Addendum to OU-1 Final Design Report

Description of Model Simulations

**Lockheed Martin
Great Neck, New York
NYSDEC Site No. 130045**

March 5, 1999

FIGURE
1

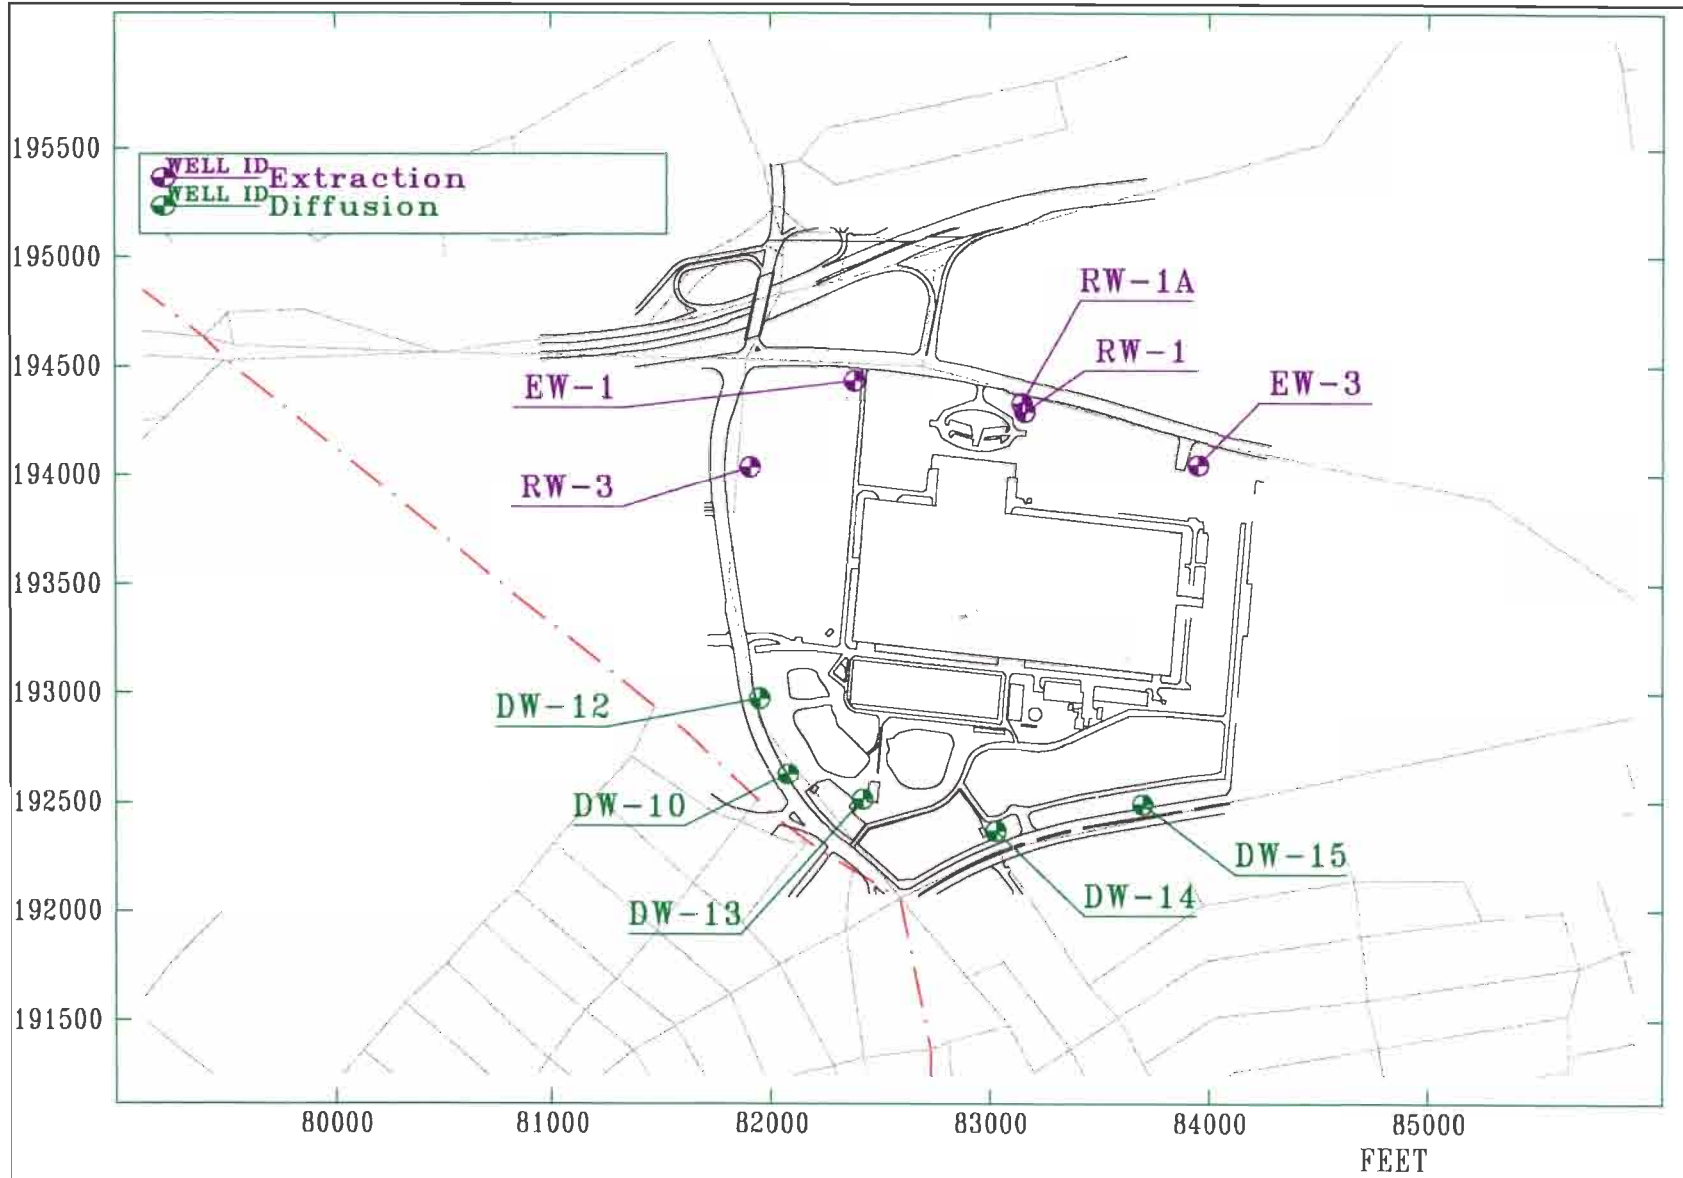
The groundwater extraction remedy specified in the Record of Decision (ROD) for the site (NYSDEC, March 1997) consists of five groundwater extraction wells pumping a total of 1,800 gpm (Figure 1). The proposed extraction wells include existing wells EW-1, RW-1 and EW-3, and new wells RW-1A and RW-3. Under the proposed groundwater remedy, once the groundwater is extracted and treated, it will be discharged to the subsurface via five diffusion (recharge) wells which will be located along the southern property line.

Model simulation of the ROD remedy indicated that the operation of extraction well EW-3 would draw part of the existing groundwater plume eastward, and may cause groundwater concentrations in the eastern portion of the site to increase. Based on a review of these modeling results, CDM and Lockheed Martin concluded that it would be undesirable to operate extraction well EW-3 as part of the OU-1 groundwater remedy because of the potential for spreading the lateral extent of the high-concentration areas of groundwater plume into less contaminated areas.

As a result, the OU-1 groundwater remedy was revised to consist of four wells (EW-1, RW-1, RW-1A and RW-3) pumping at the same combined rate of 1,800 gpm as the original remedy. For the modified remedy, groundwater extraction rates were increased by twenty percent at each well (i.e., EW-1, RW-1, RW-1A and RW-3). The location and number of the diffusion wells did not change. Table 1 lists the components of the original and final OU-1 groundwater extraction remedies.

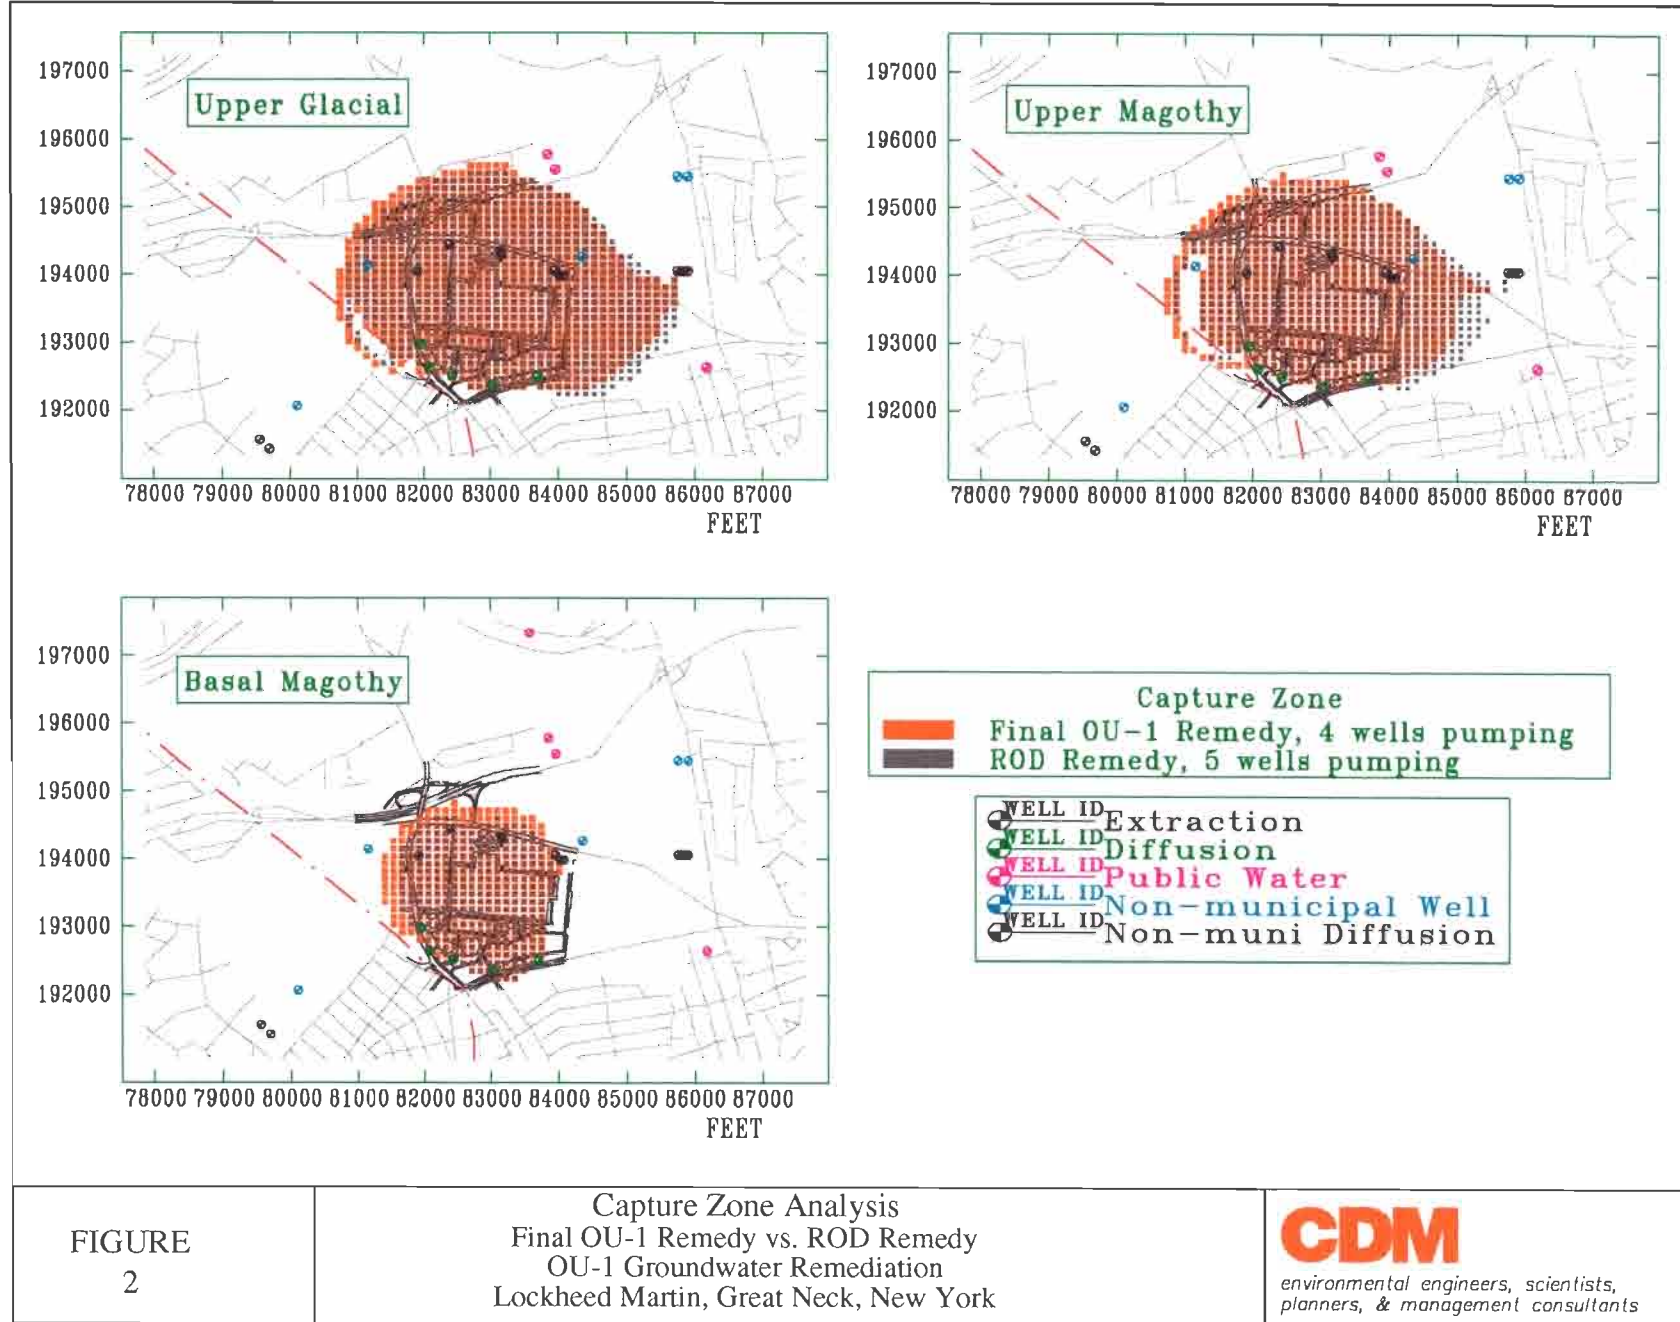
The final groundwater remedy was compared to the original remedy using steady-state capture zone analysis. Figure 2 shows the simulated capture zones for the original and final OU-1 groundwater remedy for the basal Magothy, upper Magothy and Upper Glacial model layers. The capture zones are based on a 30-year simulation period. A comparison of the simulated capture zones indicates that the hydraulic capture achieved by the two groundwater pumping scenarios is generally similar. The final OU-1 remedy imposes hydraulic control over a slightly larger area to the north and west of the site than the ROD remedy, particularly in the basal Magothy aquifer. The capture zone for the final OU-1 remedy extends slightly less far to the east of the site, where TVOC concentrations are lower than north of the site.

FIGURE
3

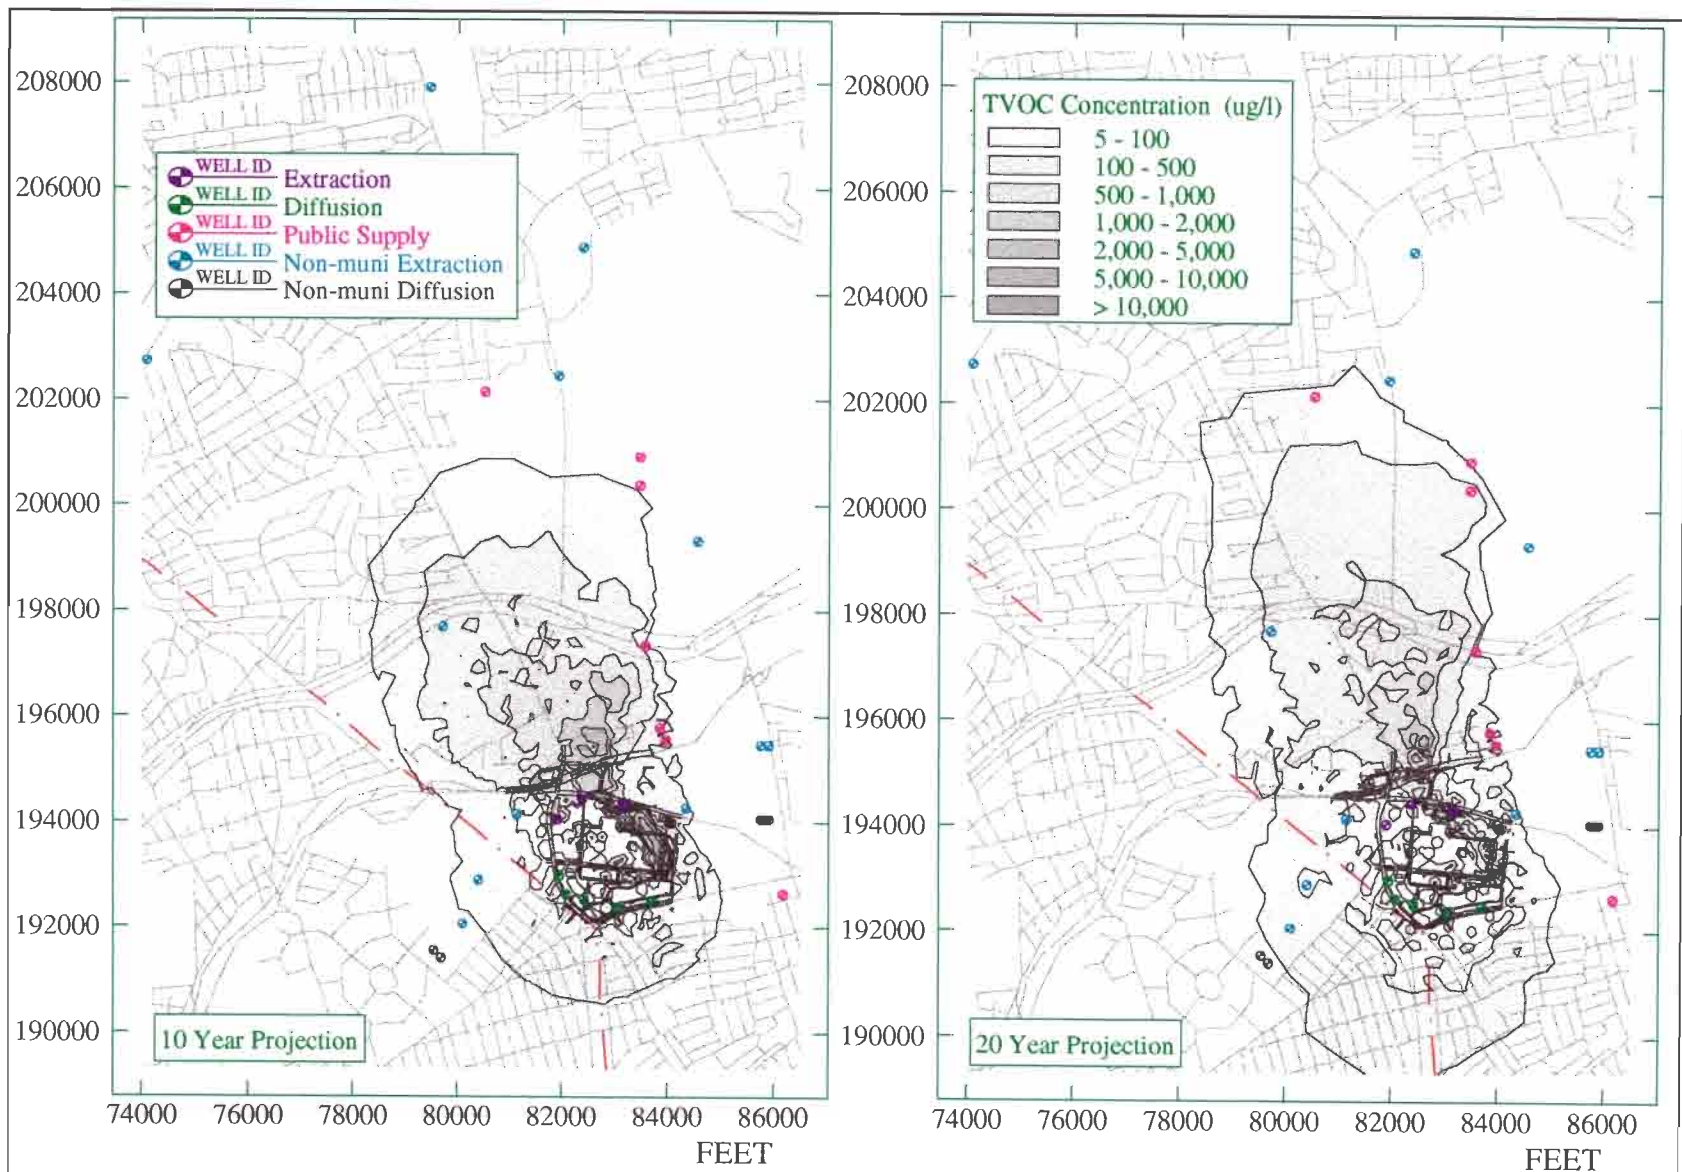
The mass transport simulations were performed to evaluate TVOC mass removal by the original ROD and final OU-1 remedy. Simulated maximum aquifer TVOC concentrations after 10 and 20 years are shown in Figure 3. The simulated mass removal for the two scenarios were compared over a projected operation period of twenty years. The results of this comparison are presented in the table below and shown graphically in Figure 4. Comparison of simulated mass removal indicates that the final OU-1 groundwater remedy removes slightly more contaminant mass from the groundwater system. More contaminant mass is removed by the modified remedy due to increased groundwater pumping in the high TVOC concentration area of the groundwater plume.
